# SERVICE BULLETIN

**SB 70-191**

**SUBJECT** : AILERON CONTROL CABLES

**EFFECTIVITY** : TBM 700 and TBM 850 aircraft S/N 1 to 572, 574, 576

Figure 1 – Aileron control cables

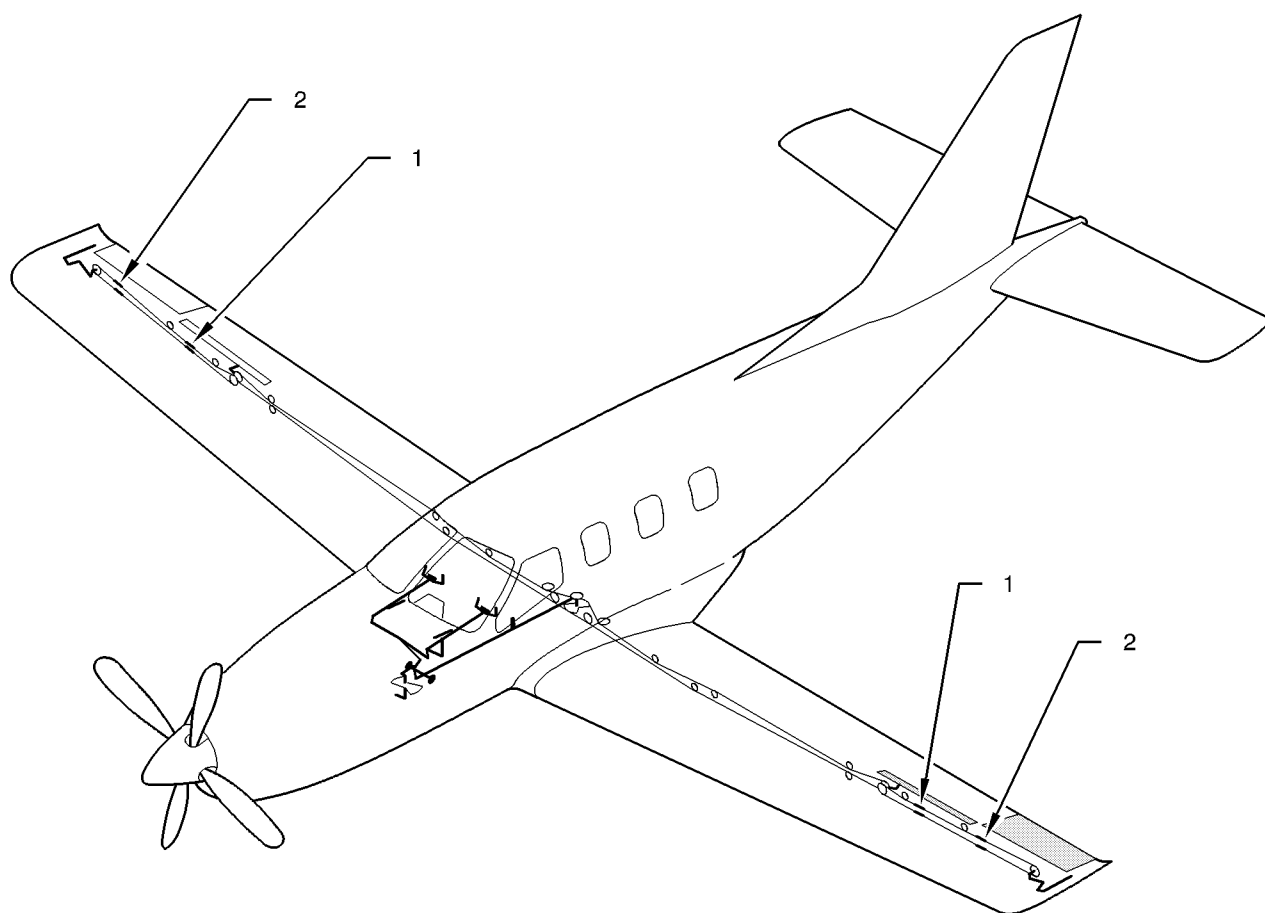
- 3) Lift L.H. aileron and visually check, through spoiler aperture, that cable tighteners are visible – see Figure 1.
- 4) Repeat the operation for R.H. aileron.
- 5) If cable tighteners are present at the level of spoilers, the installation is correct (1) : refer to Paragraph C.
- 6) If cable tighteners are not visible, the installation is incorrect (2) : refer to Paragraph B.

- 1) Remove R.H. and/or L.H. aileron control cables – refer to Chapter 27–10–03 of the Maintenance Manual.
- 2) Reverse the direction of cables as per the described procedure – refer to Chapter 27–10–03 of the Maintenance Manual.
